Plot 10a, First Street

Response to MCC Comments – Note 01

April 2023

PL1471.2-PLA-GF-00-DR-L-011

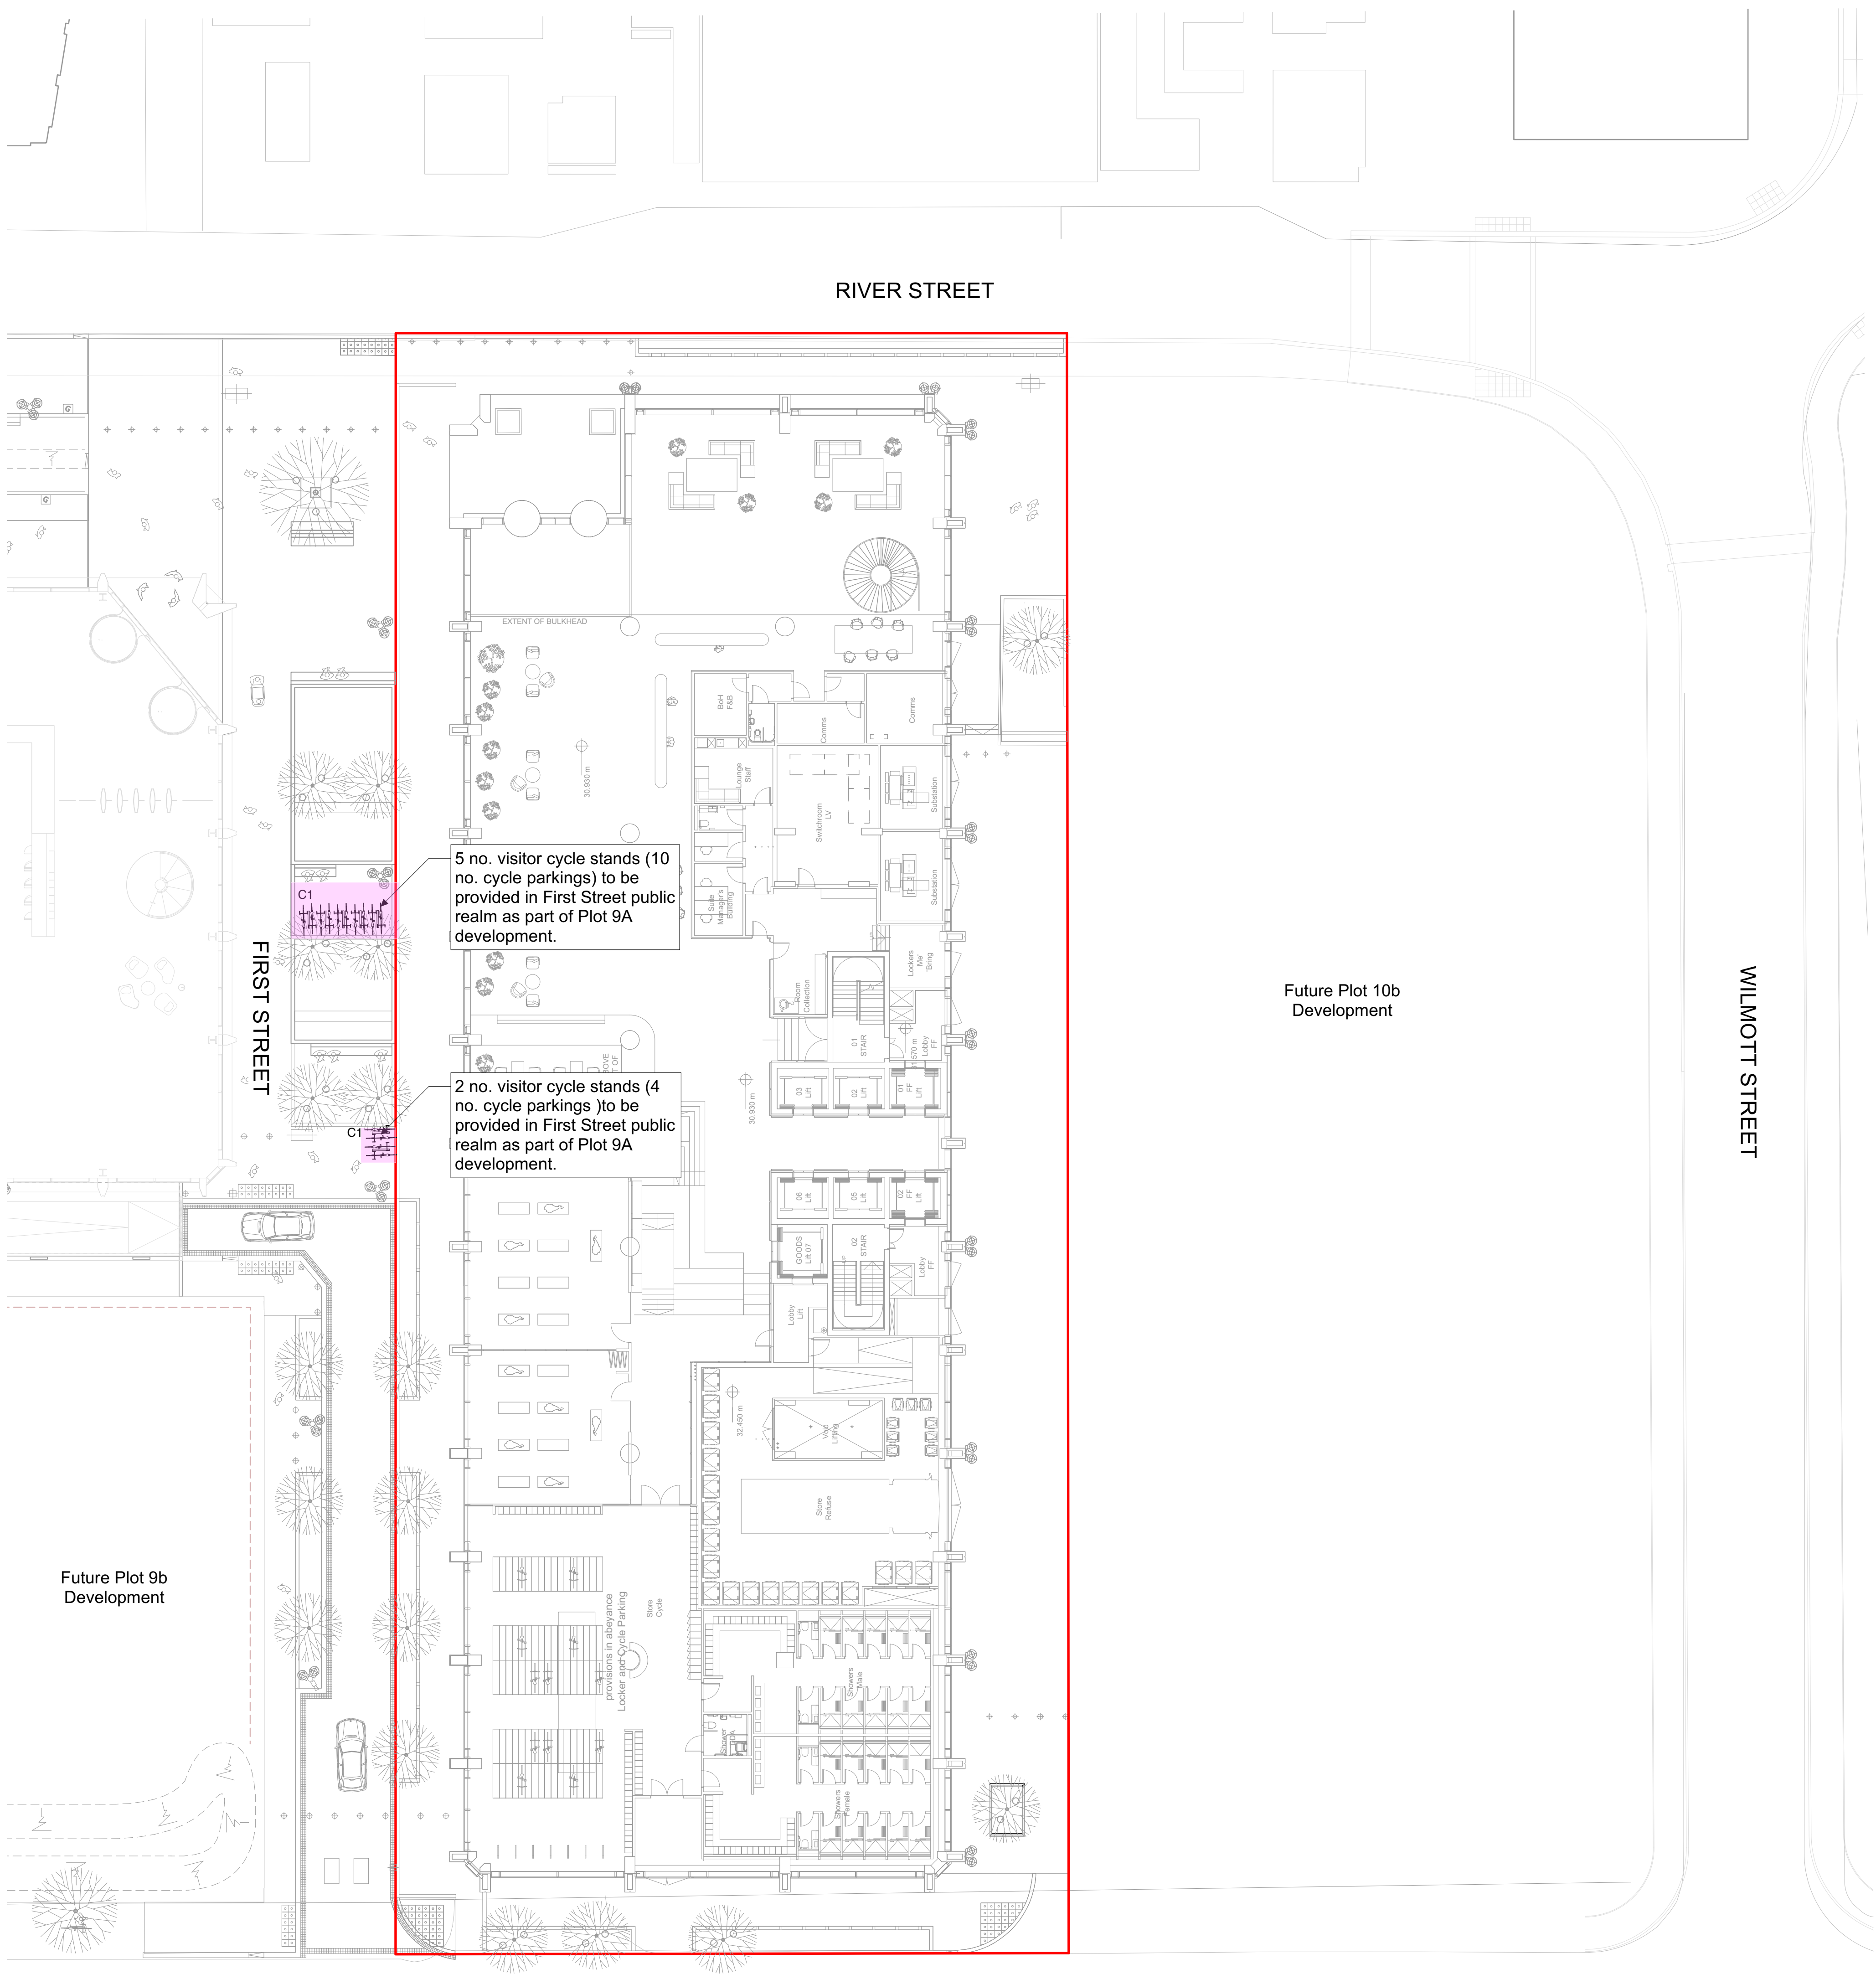
“It would be beneficial to understand if any cycle parking is proposed for short stay trips / visitors. It is recommended that some provision is made external to the proposed building.”

Firstly in context there are 28 cycle spaces in Sheffield Stands located in Grigor Square opposite. There will also be 12 Cycle Spaces in Sheffield stands located to the east as part of the Plot 10b development.

An additional 12 cycle parking spaces is now provided in the First Street public realm located to the west of Plot 10a as shown in Dwg PL1471.2-PLA-GF-00-DR-L-011 overleaf.

Cycle parking demand across the development should be monitored as part of the Travel Plan with additional cycle parking provision provided if necessary.

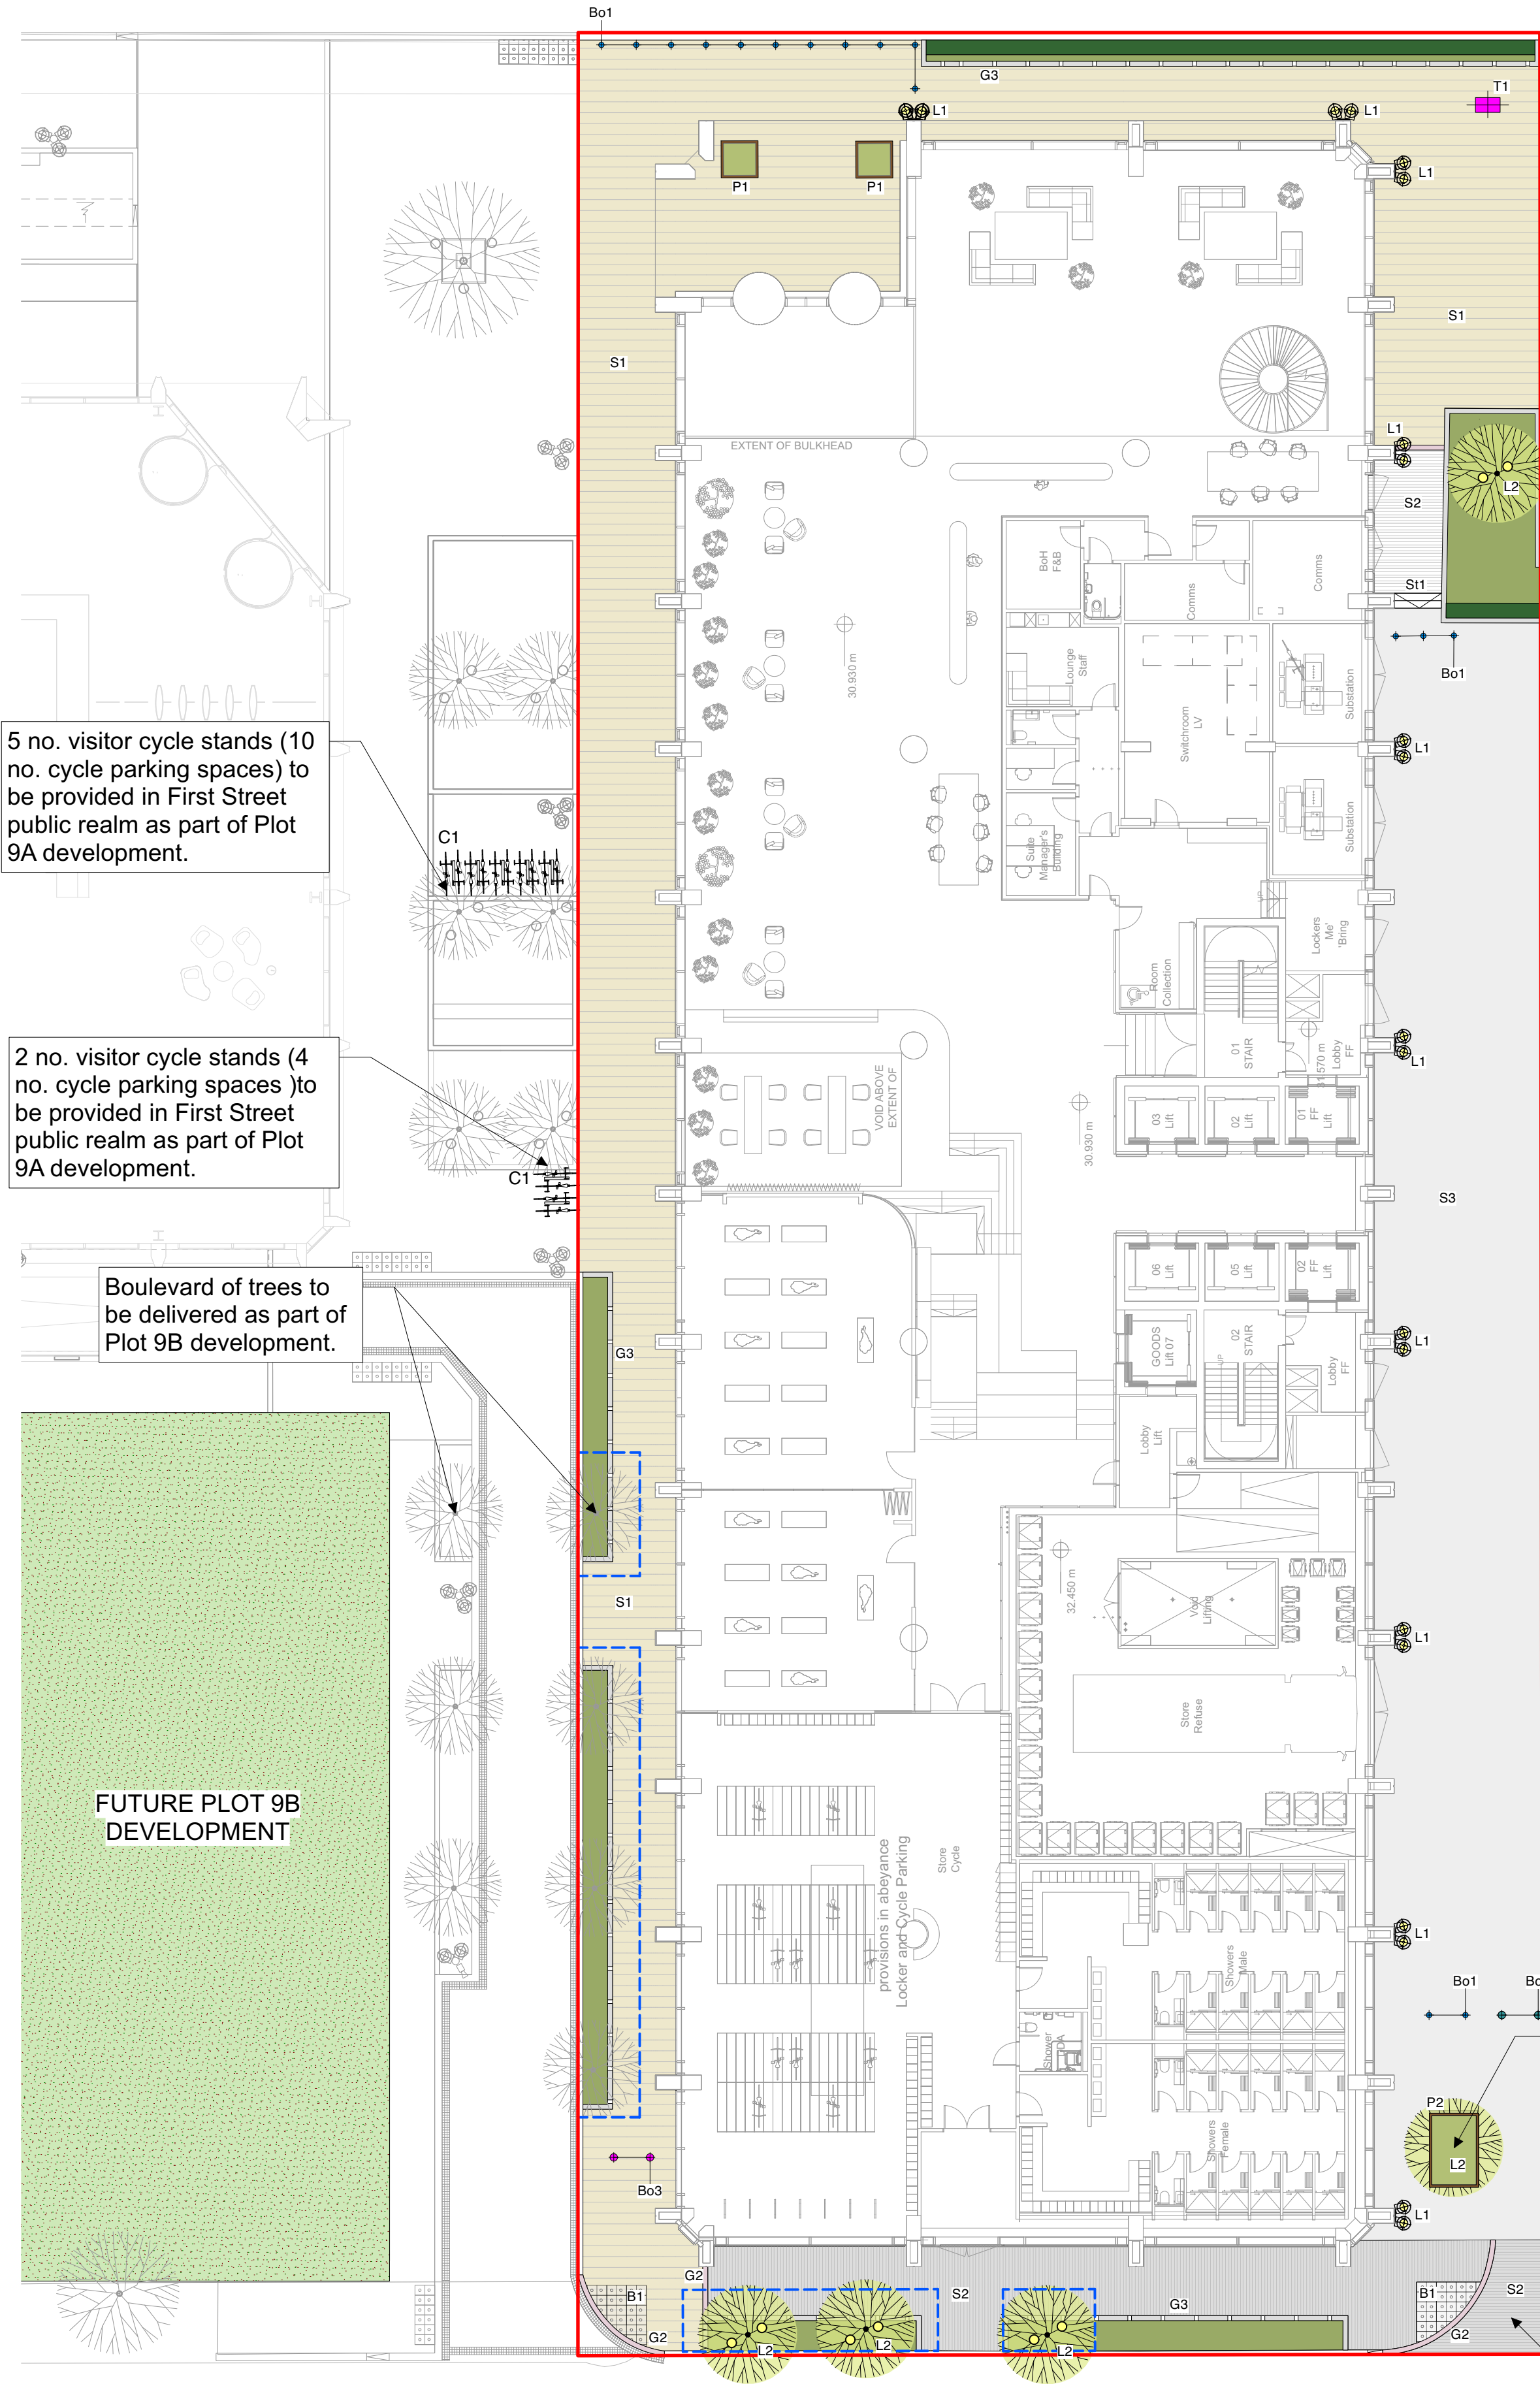
- The developer needs to demonstrate that a safe access is achievable for the interim servicing arrangements. At present the submitted plans suggest that the interim access will be within close proximity of the building edge of Plot 10a and vehicles will reverse over proposed dropped kerbs, footway and tactile paving. In order for Highways to provide a response we will need to see a proposed interim access drawing with an acceptable and achievable access radius, sight lines and swept path.

For clarity the Access would be designed with a sacrificial temporary surface. This would be finished with a high quality surface once both Plot 10 buildings are complete. These works would be specified as part of the detail highway design.
